Technical Review of Long-Throated Flume and Labyrinth Weir
Hydraulics for Newtown Creek Water Pollution Control Plant
Upgrade

Subject: Review of Newtown Creek WPCP Long-Throated Flume and Labyrinth Weir
Hydraulics

Technical Review of Long-Throated Flume and Labyrinth Weir Hydraulics for Newtown Creek Water Pollution Control Plant Upgrade

Figure 3. — Computed water surface profiles in exit channels of labyrinth weir, for original design.

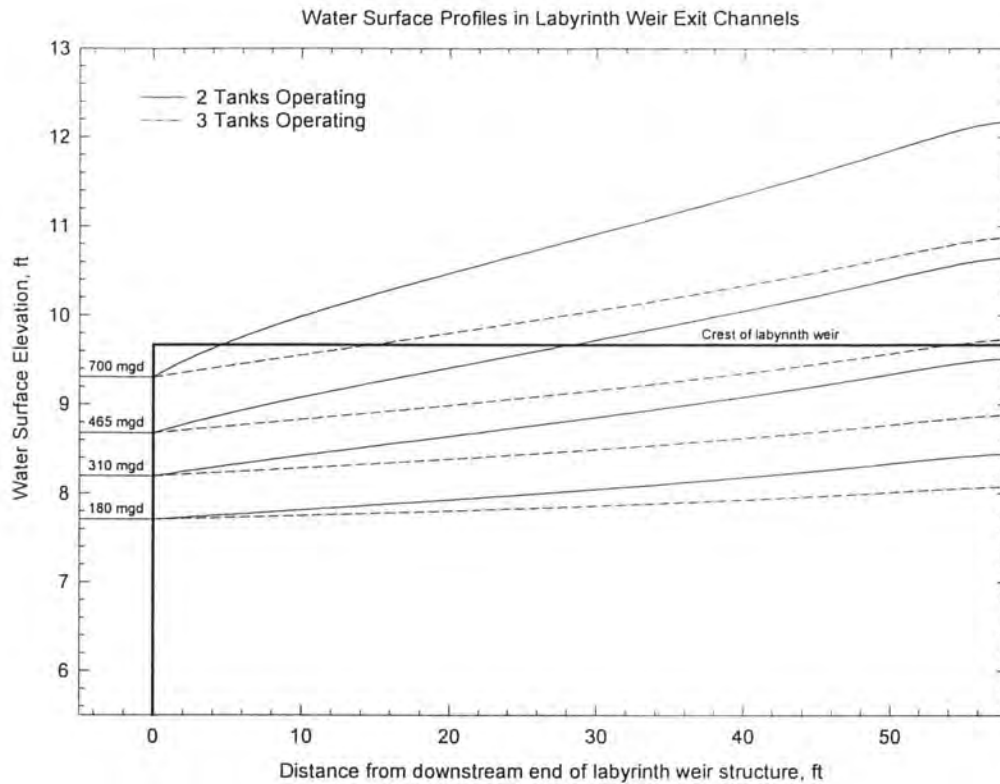
calculations begin from the flow depth previously computed at the upstream end of the approach channel (i.e., downstream end of the labyrinth weir). These data are shown in the last column of table 1. The calculations proceed in the upstream direction. It was assumed that flow entered the exit channel uniformly over the 58-ft length of each labyrinth weir. Table 2 shows a summary of the results for each of the four primary flow rates (180, 310, 465, and 700 mgd) under the two-tank and three-tank operating scenarios. Figure 3 shows the computed water surface profiles under each flow condition. Appendix E contains an example of the spreadsheet used to make these calculations. Figure 3 shows that the labyrinth weir crests, which are at elevation 9.67 ft, will be partially submerged at the maximum and peak flow levels (465 mgd and 700 mgd). For these cases, the water surface profiles shown in Figure 3 are only rough approximations, since the partial submergence of the weir crest invalidates the assumption of uniform inflow to the exit channel.

Figure 2. — Computed water surface profiles in labyrinth weir exit channels.

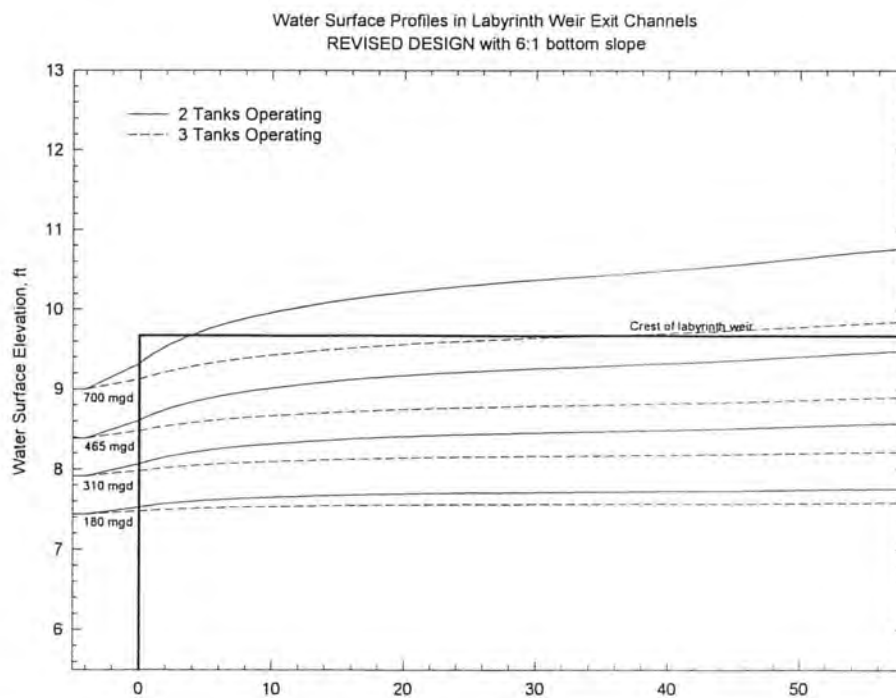
The revised design of the exit channels reduced their floor elevation to 0.00 ft in the upstream half (first 29 ft) and then provided a 6:1 or 8:1 transition into the flume approach channel. These two scenarios (6:1 vs. 8:1 transition) were analyzed in combination with the backwater profiles obtained for the revised flume design. The results are summarized in table 3. There is only a slight improvement in the water surface profiles with the 8:1 slope, and either case will perform properly at flows as high as 465 mgd. At a flow of 700 mgd, there will some submergence of the upstream portions of the labyrinth weir crest.

Figure 4. — Labyrinth weir nomenclature and recommended dimensions (Tullis, et al., 1995) and initial labyrinth weir layout for the Newtown Creek WPCP upgrade.

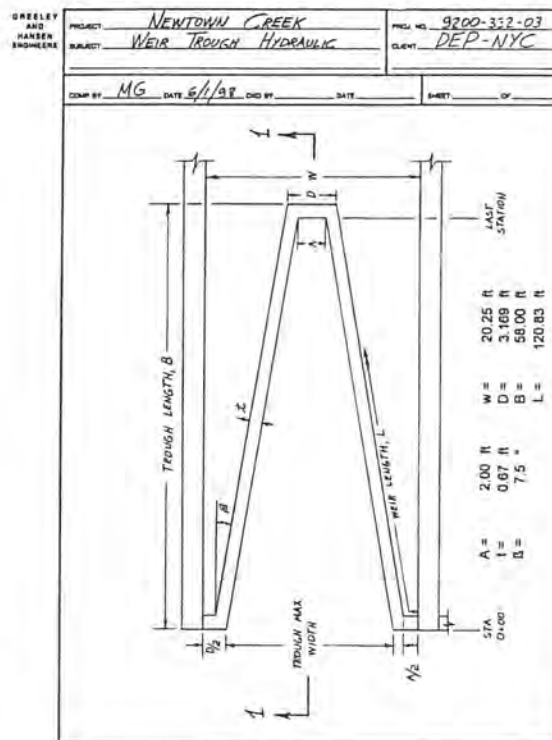
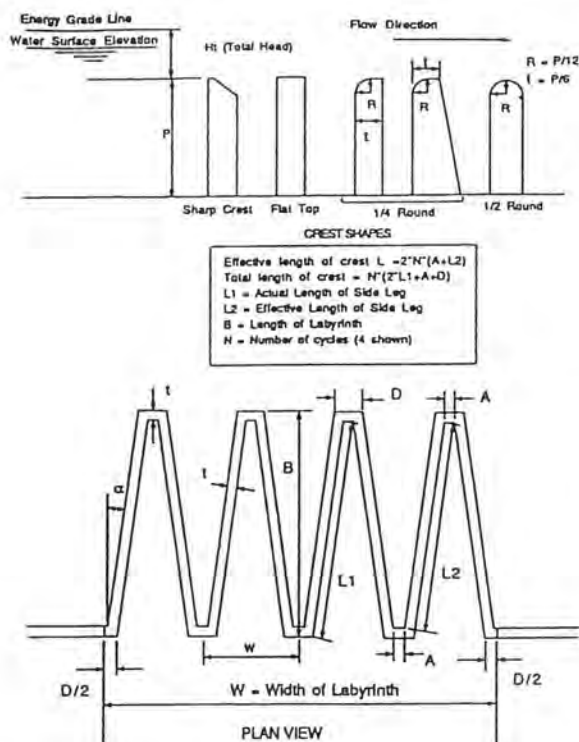
A plan view of a single labyrinth cycle is shown in Figure 4. The weir crest is an 8-inch thick concrete wall up to elevation 9.42 ft, topped by an unspecified sharp crest at elevation 9.67 ft.

A figure in Tullis, et al. was used to determine C_d as a function of the weir angle $\alpha=7.5^\circ$, and the ratio of H/P . Table 4 summarizes the calculations and results. The water levels required in the contact tanks to obtain flows of 233.33 mgd/cycle and 350 mgd/cycle are 10.98 ft and 11.63 ft, respectively. These are 0.37 ft and 0.72 ft higher than the levels computed by Greeley and Hansen. If a quarter-round crest shape is used, water levels of 10.80 ft and 11.31 ft are required. It should be emphasized that these calculations assume free flow over the labyrinth weir; the discharge capacity will be further reduced when the weir crests are partially submerged, as the previous analysis of the exit channel water surface profiles indicated.

- Labyrinth weir discharge capacities were revised to reflect the fact that a sharp crest will be retained in the design for constructability and to facilitate future modifications. A water surface elevation of 10.98 ft is required upstream of the labyrinth weir to drive 233.33 mgd/cycle over the labyrinth weir, compared to 10.80 ft using a quarter-round crest shape.

SECTION 3

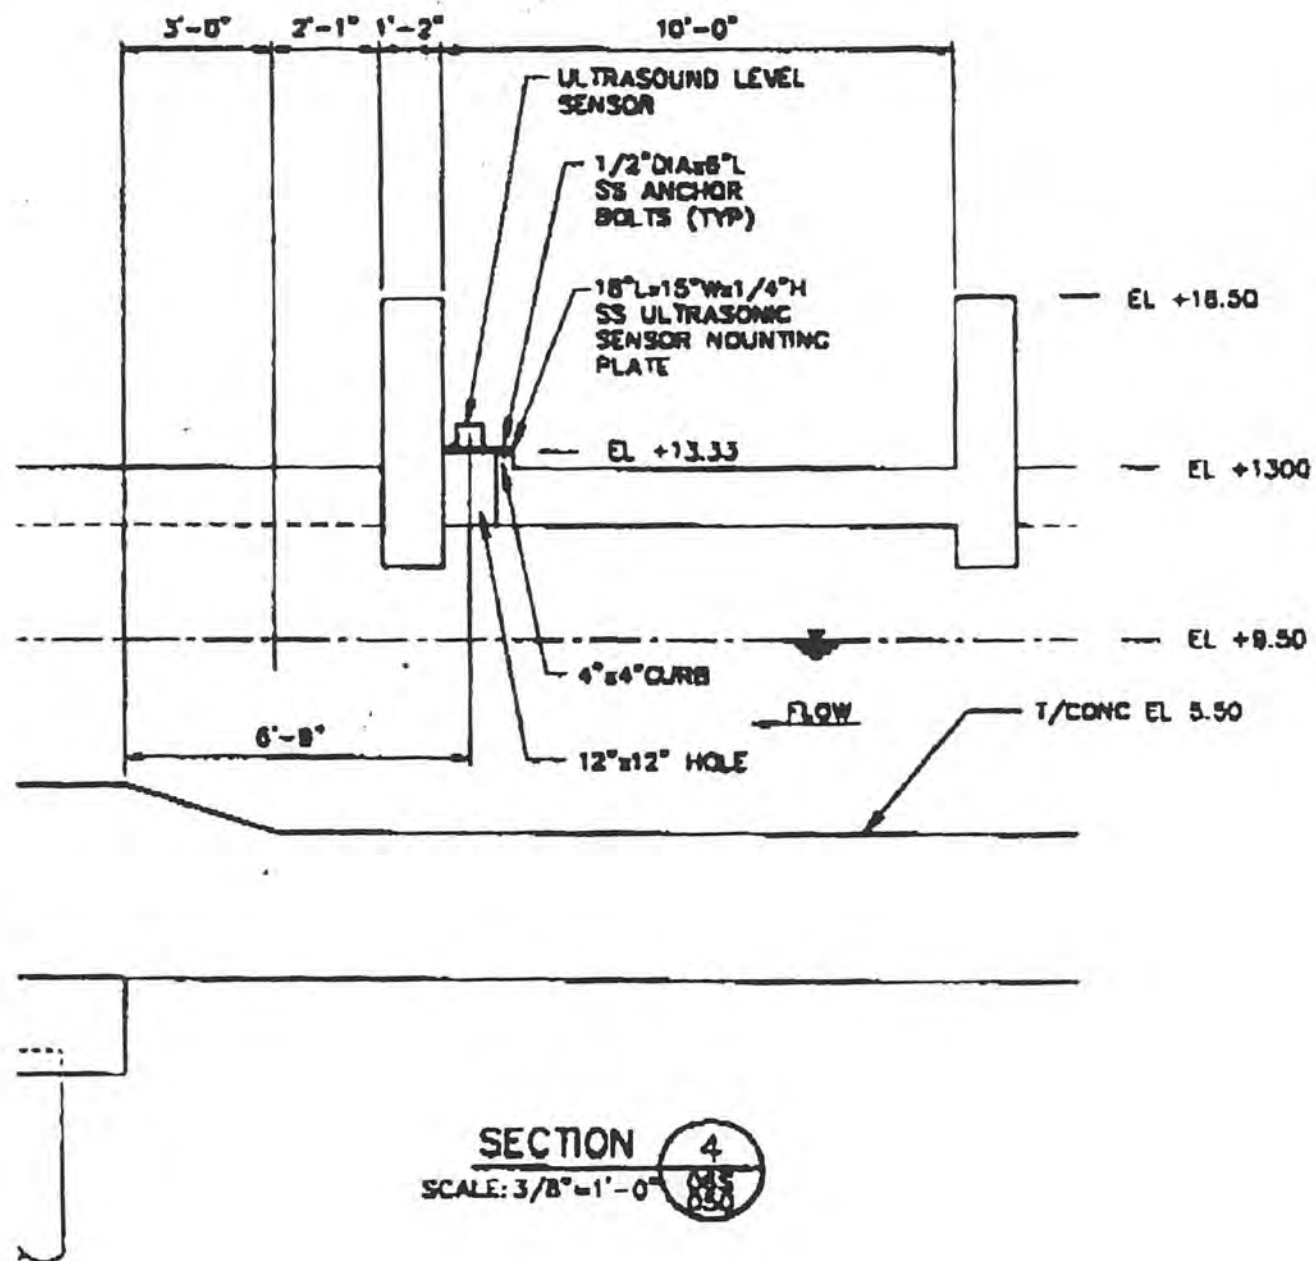
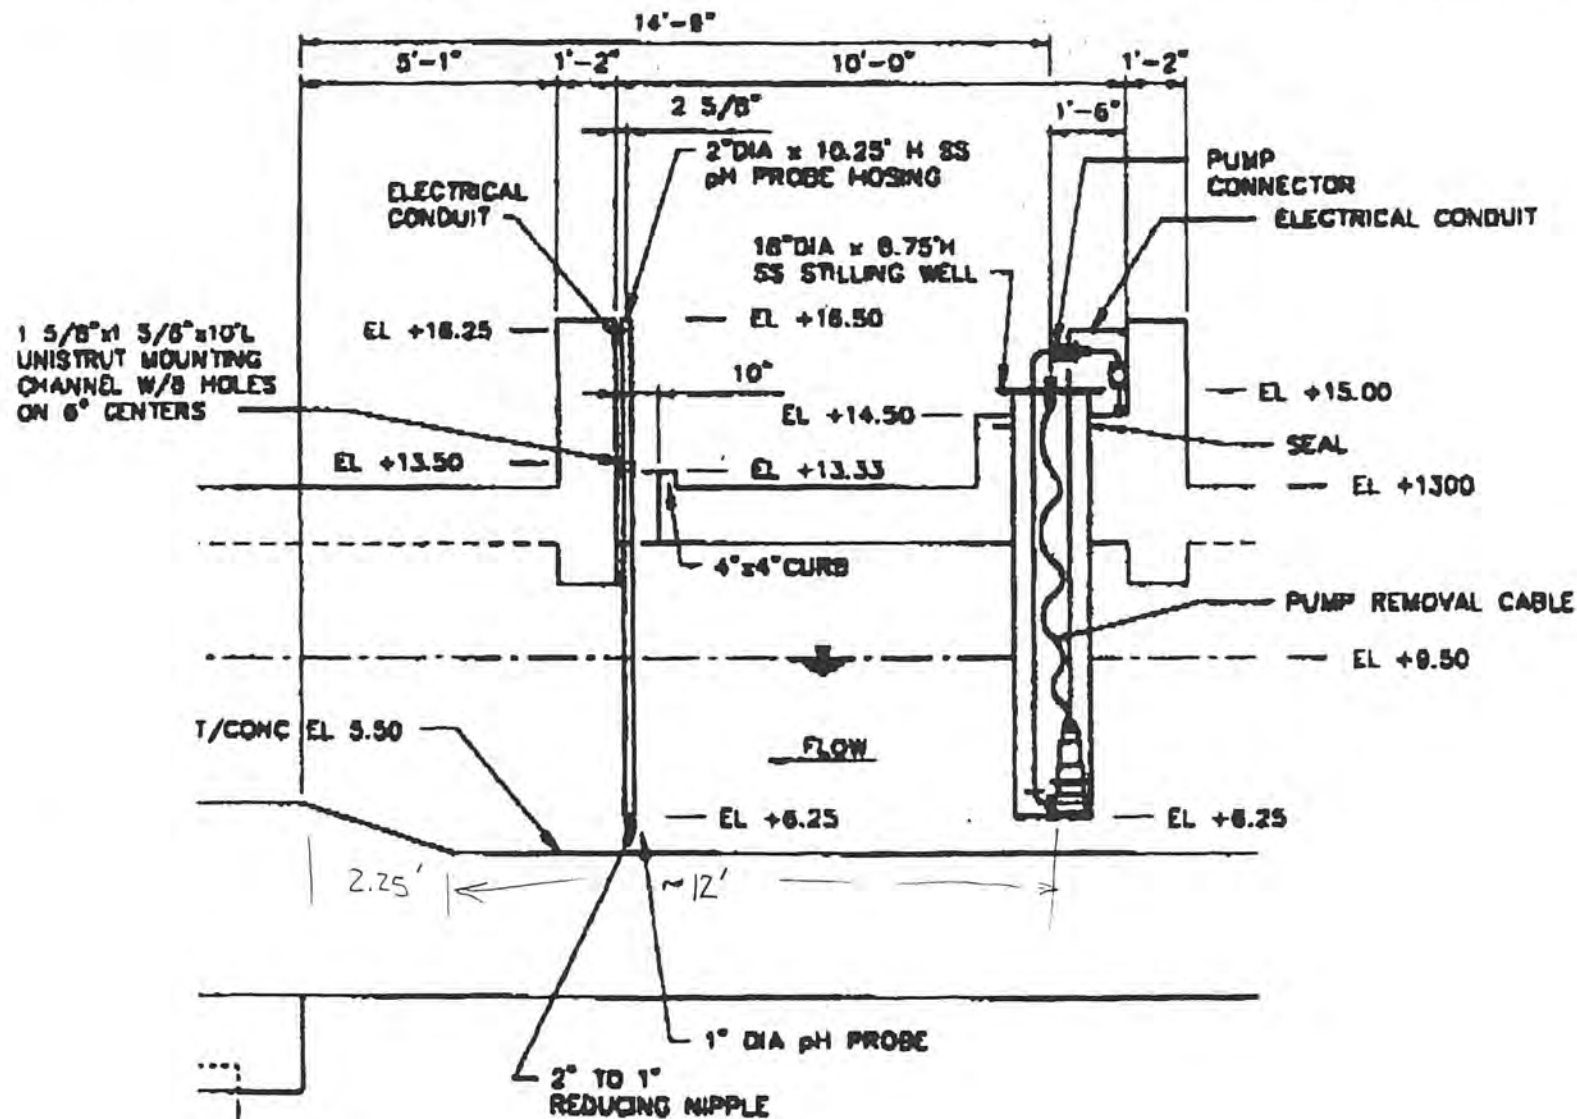
1. VERIFY GAUGING STATION LOCATION AT 6'-9" FROM UPSTREAM EDGE OF FLUME CREST.
2. VERIFY REVISIONS OF FLUME DOWNSTREAM SLOPE AND CREST HEIGHT MEET RECOMMENDATIONS FROM WRRL FOR OPTIMUM PERFORMANCE.
3. COMMENT ON SUGGESTION OF ADDING A STEEL PLATE OVER FLUME CREST FOR MAINTAINING A UNIFORM SMOOTH SURFACE AT CREST.

- The long-throated flume design was evaluated using the WinFlume software to confirm that the gaging station location 6'-9" from the upstream edge of the flume crest is satisfactory. The gage location could be moved to as close as 6'-3" from the flume crest if necessary. The downstream slope and sill height are also appropriate and will lead to reduced head loss across the flume compared to the original design. Also, the addition of a steel plate on the flume crest as proposed by Greeley and Hansen is a good means for maintaining a uniform smooth surface at the crest.

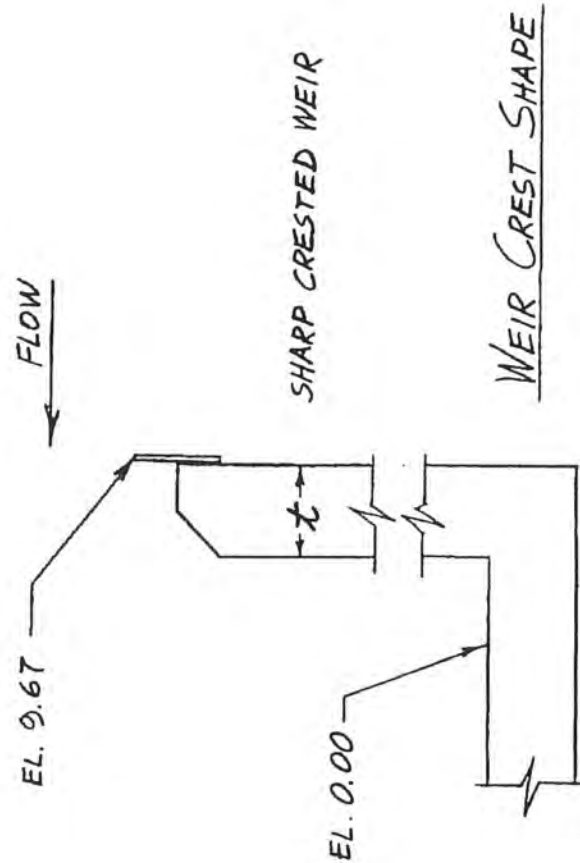
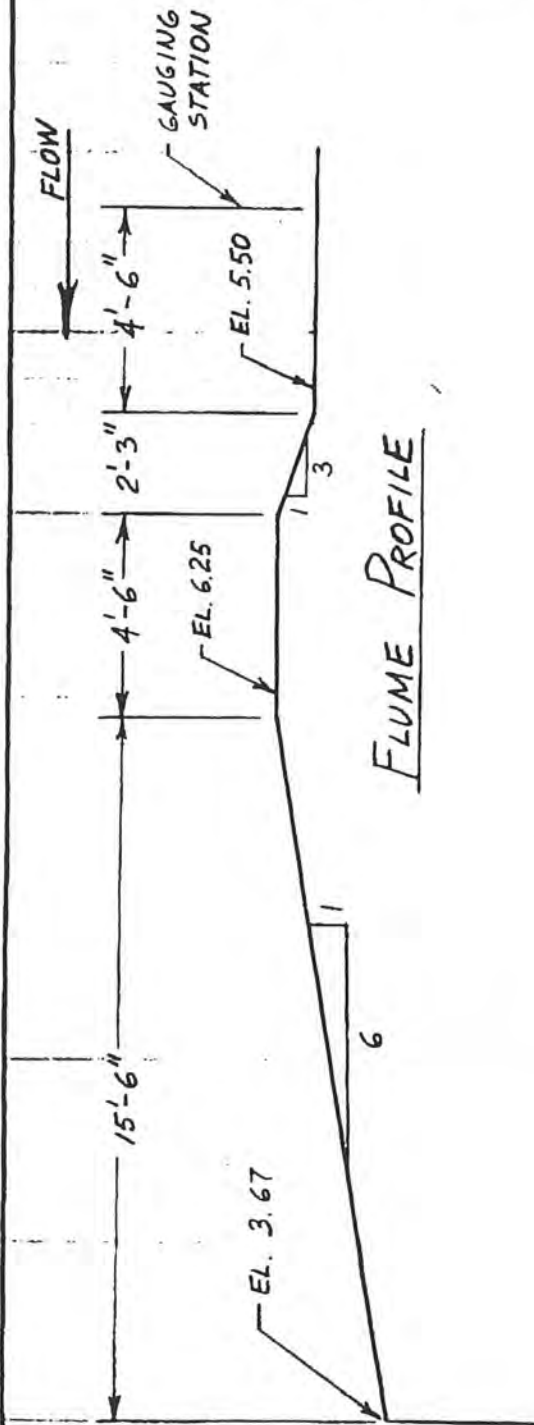
EXPLORE 1:6 SLOPE OR 1:8 IN ANALYSIS.
(1:6 IS PREFERRED FROM A DESIGN STANDPOINT.)

- Water surface profiles in the troughs downstream of the labyrinth weirs were recomputed using an invert elevation of 0.00 ft in the upstream ends of the troughs. The choice of a 6:1 or 8:1 slope in the transition from the troughs to the long-throated flume approach channel had only a slight effect on the profiles.
